Application Number: DA2023/1107

Proposed Development: Change of use and alterations and additions to Office C for the purpose of a childcare center and landscaping

Land to be developed (Address): Lot 1 DP 1282038 , 4 - 8 Inman Road CROMER NSW 2099

## NOTES REGARDING LANDSCAPE REFERRAL RESPONSE FROM NORTHERN BEACHES COUNCIL:

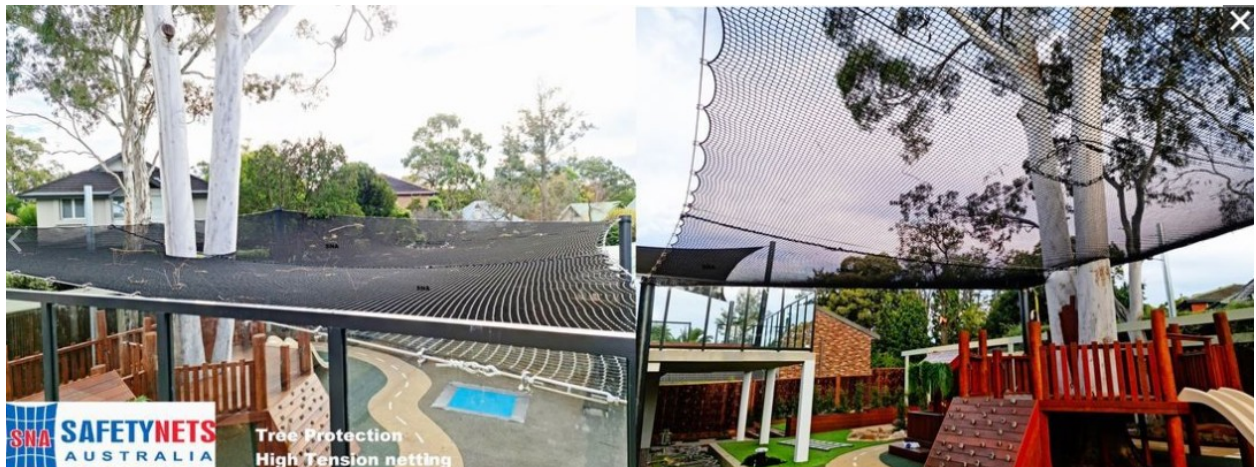
4.0 *The Tree Risk Assessment shows 6 trees to be removed and the plans show 10 trees to be removed; please coordinate and clarify. Trees that have previously been removed shall be identified to avoid confusion.*

4.1 Regarding tree removals following a review the only trees proposed to be removed are:

- T063 – *Lagunaria patersonii* - Norfolk Island Hibiscus
- T068 – *Plumeria rubra* – Frangipani
- T072 - *Melaleuca bracteata* – Tea-tree

4.2 The landscape plan is amended to reflect this. Additional endemic species of trees will be planted to replace removed Melaleuca. It is proposed to replace the four removed plants with eight trees, species selected from the Northern Beaches Council Narrabeen Ward species list and include:
